IN THE DRAWINGS

REMARKS

Fig. A2
 (DE 2805438)

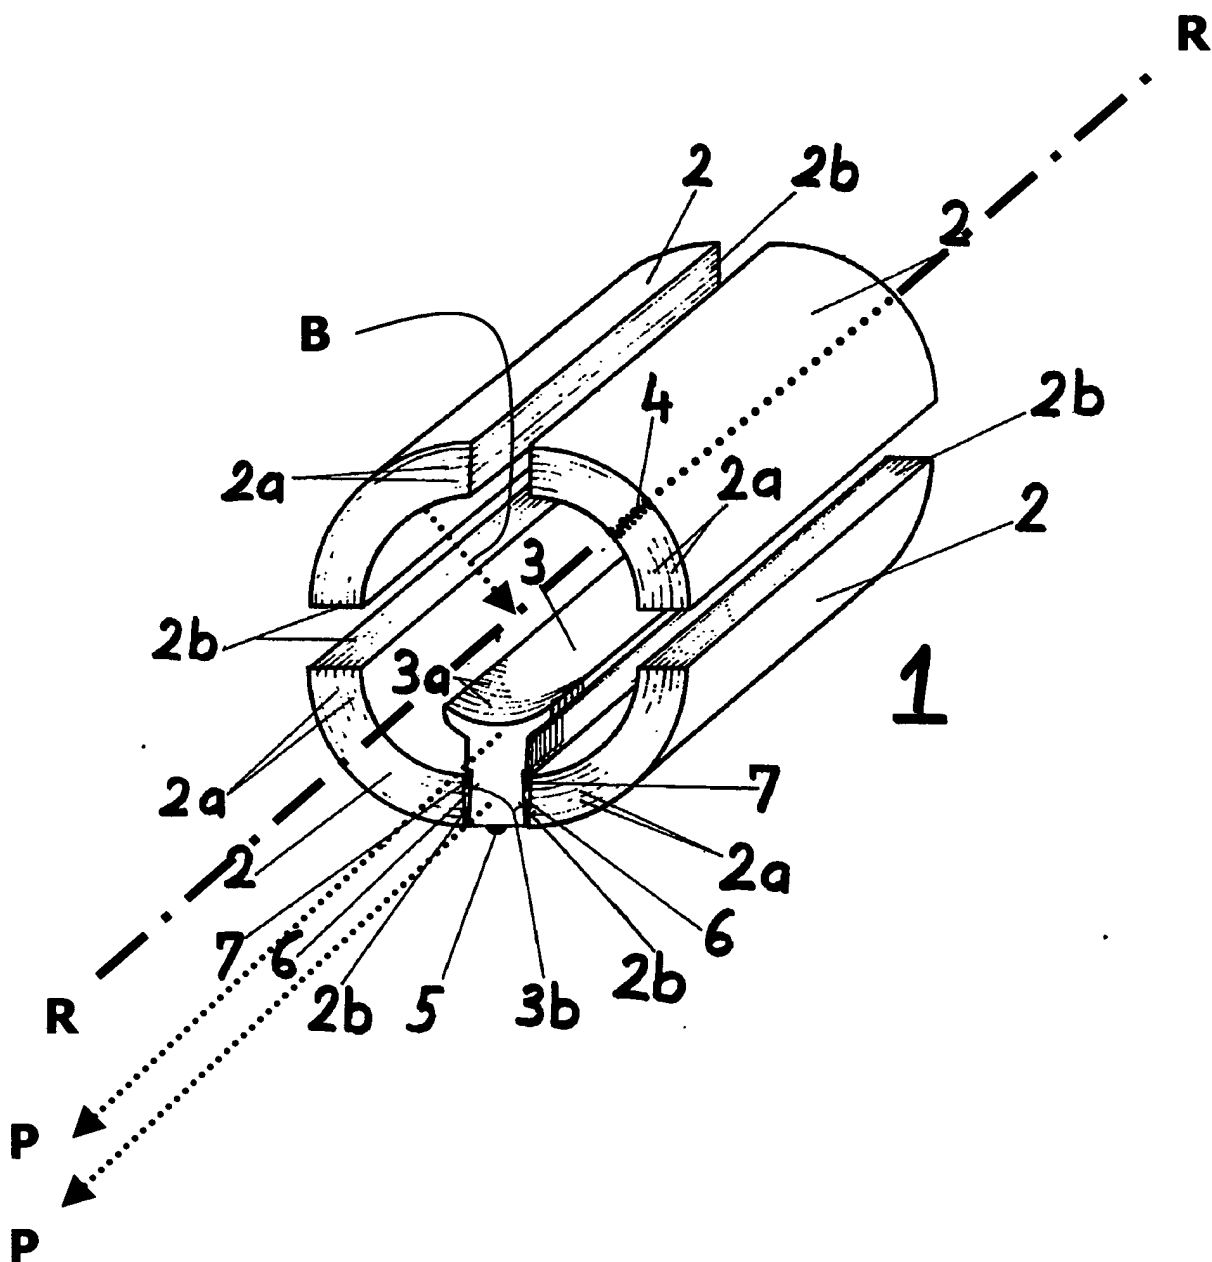
“The Applicant’s argument that the edge of the strips is not a surface is not persuasive. The drawings of ‘438 show the edge having dimension along the axis of the core, so it is a surface. The Applicant’s argument that the edge is not the ‘top’ or ‘bottom’ surface is not persuasive. The radial inner

and outer surfaces of the segment are *the top and bottom surfaces of the segment*, which is consistent with the plain meaning of the terms because there is nothing above or below those surfaces. The edge surfaces are the top most and the bottom most surfaces of the laminations of the segment. The examiner has included a written description rejection and a drawing objection because the applicant's argued top/bottom surfaces (the ones with the larger surface area) are NOT shown in the drawings or described in the specification to be perpendicular to the axis of rotation. Particularly, the Examiner notes that Figure 4b does not show that a line perpendicular to the top surfaces 231 of the teeth being perpendicular (crossing at 90 degrees) to the axis of rotation." (italics added)

Fig. A3
(DE 2805438)

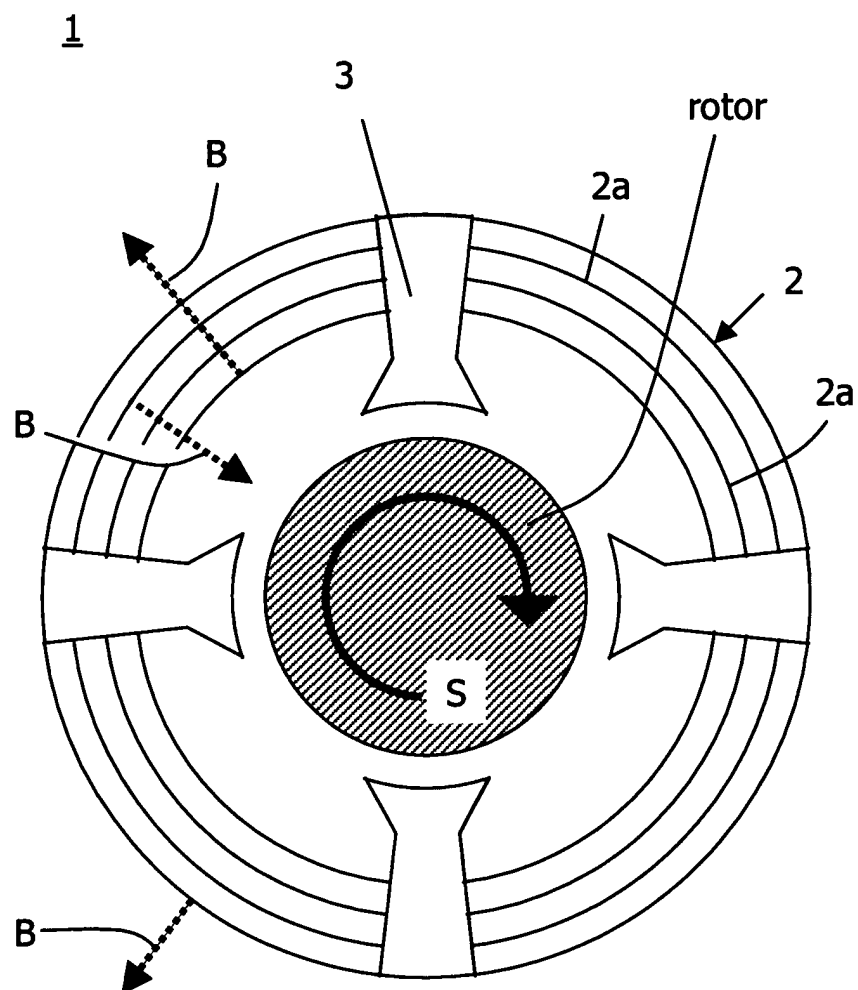
The Examiner's attention is respectfully drawn to Fig. A5, submitted herewith, which is adapted from Fig. A3 as submitted in connection with Applicants' appeal brief dated November 6, 2002. Fig. A5 depicts the magnetic structure provided in the Figure of the '438 patent. For greater clarity, the structure is drawn in end-on, cross-sectional view. Generally stated, the structure comprises four back-iron sections 2 and four pole shoe sections 3. Applicants agree that each of the *segments* that comprise the '438 magnetic structure has plural surfaces. In particular, applicants agree that each section 2 and each section 3, taken as a whole, has a radially inward-facing surface and a radially outward-facing surface. For convenience these surfaces are labeled IS2 and OS2 for sections 2 and IS3 and OS3 for sections 3 in Fig. A5.

However, applicants maintain that the structure of shoe sections 3, as oriented and assembled in a stator in accordance with the Figure of '438, fails to satisfy the configurational requirement of claim 1 and that the Examiner's conclusion otherwise is based on an incorrect reading of the claim. In the portion of the rejection of October 10, 2003 quoted hereinabove, the phrase emphasized speaks of the surfaces of the *segment*, not the surfaces of the *strips*, as delineated by Applicants' claims. Thus, the surfaces labeled IS3 and OS3, while admittedly surfaces of *segments* 3, are not the surfaces of any of the *strips* comprised in the segments 3. Applicants' claims expressly require perpendicular orientation of the surfaces of strip, not surfaces of segments.

Lines normal to surfaces IS3 and OS3 at substantially any point thereof are admittedly perpendicular to the axis of rotation of the rotor. However, shoe segments 3 comprise a plurality of individual layers of (crystalline) magnetic metal strip that are stacked in registry. Each of the layers in the Fig. A5 configuration is identical in shape and has a top surface and a bottom surface. Lines normal to the layers comprised in segments 3 at any point thereon are submitted to be *parallel* to the rotation axis, i.e., perpendicular to the page of Fig. A5, and not *perpendicular* to the rotation axis, as required by claim 1.
